SERVICE CHANGES: TD003G

1. Changes on Rotor and Felt

(T/I#DT585)

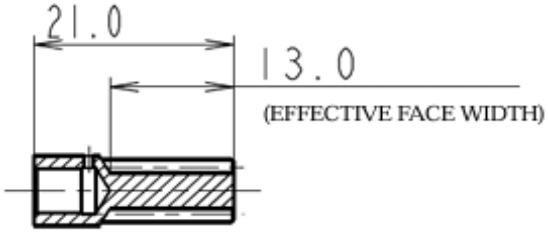
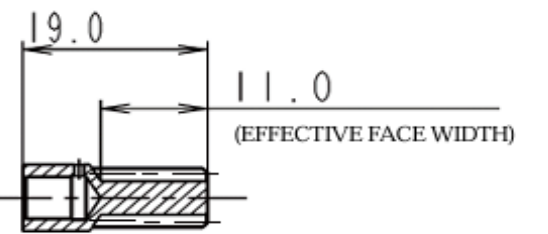
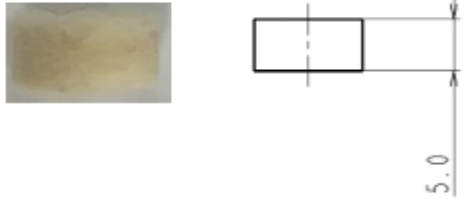
Item No.	Description	Type 1	Type 2
24	FELT	422994-3	422B40-4
35	ROTOR	619808-7	619877-8

Current	New
Rotor	619808-7  59.5mm SHAFT EDGE TO GEAR	619877-8  57.5mm SHAFT EDGE TO GEAR
Spur gear 7	 21.0 13.0 (EFFECTIVE FACE WIDTH)	 19.0 11.0 (EFFECTIVE FACE WIDTH)
Felt	422994-3  3.0	422B40-4  5.0

Above parts are completely interchangeable as a set.
